Contract #: 04-0120F4  
 Cty: SF/ALA Rte: 80 PM: 13.2/13.9  
 File #: 69.25B

## QUALITY ASSURANCE -- NON-CONFORMANCE REPORT

**Report No:** NCR-000576

**Reference Description:** Weld Repair without Engineer's Approval (CWR) and without WPS, Weld OBE5-004, Segments 5AE/5BE

UT-5E-006 P/2

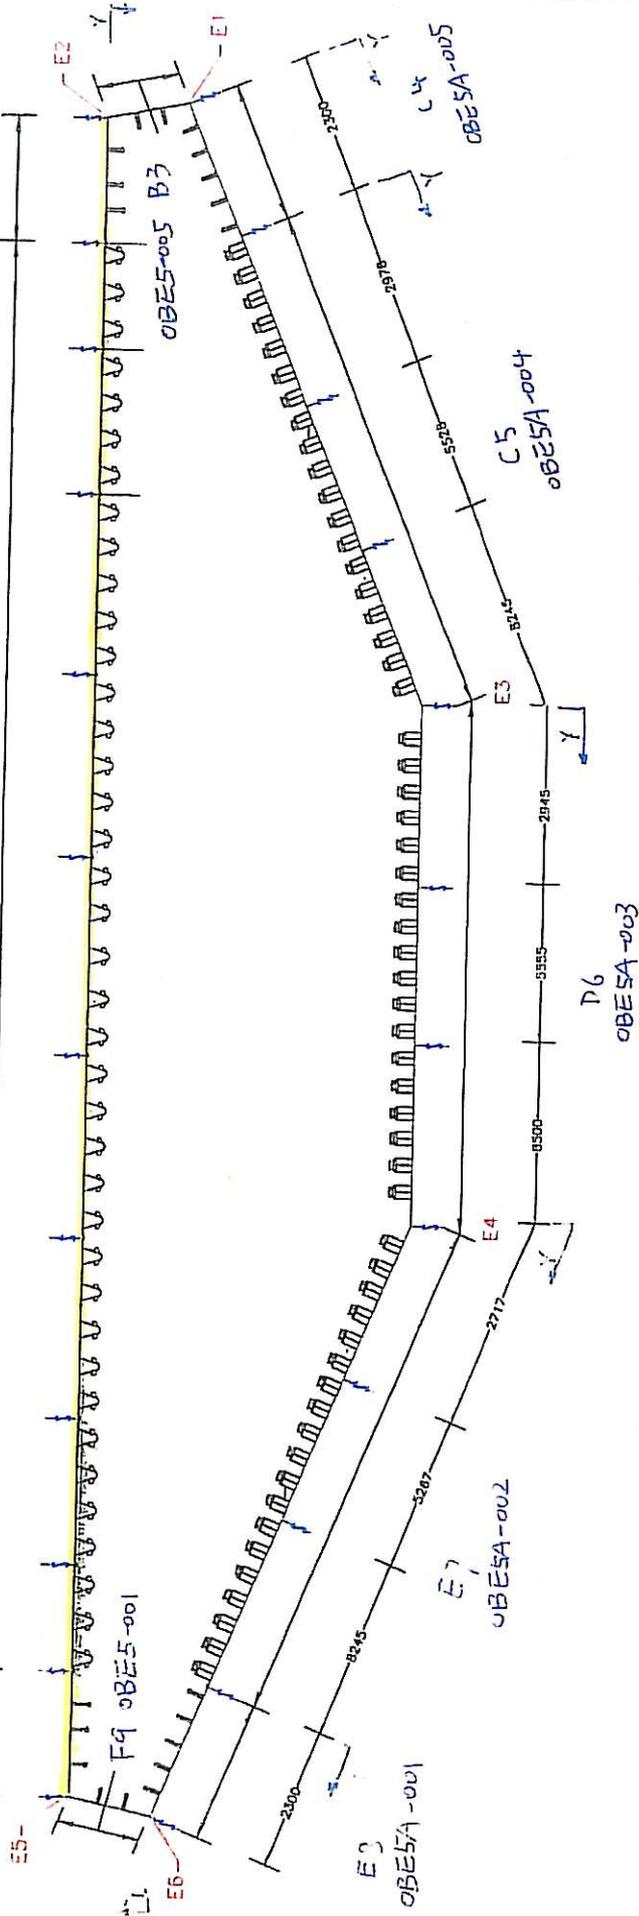
- Weld repair was performed without the Engineer's approval.
- No approved welding procedure specification (WPS) was onsite during the welding repair process.
- This weld is identified as: OBE5-004
- Y location is 710mm measured from the Counter Weight side on the interior of the Deck Plate at Panel Point (PP32).
- This is a second time weld repair performed on a Transverse Indication.
- ZPMC discovered this indication utilizing the Magnetic Particle (MT) method.
- Lift 5 East is located in the OGB Trial Assembly Area.

During the Quality Assurance in-process visual inspection of lift 5 East, the QA inspector (QA) discovered the following issues:

Submit a repair procedure to the engineer for approval. Notify the engineer prior to starting the repair work. A response for the resolution of this issue is expected within 7 days.
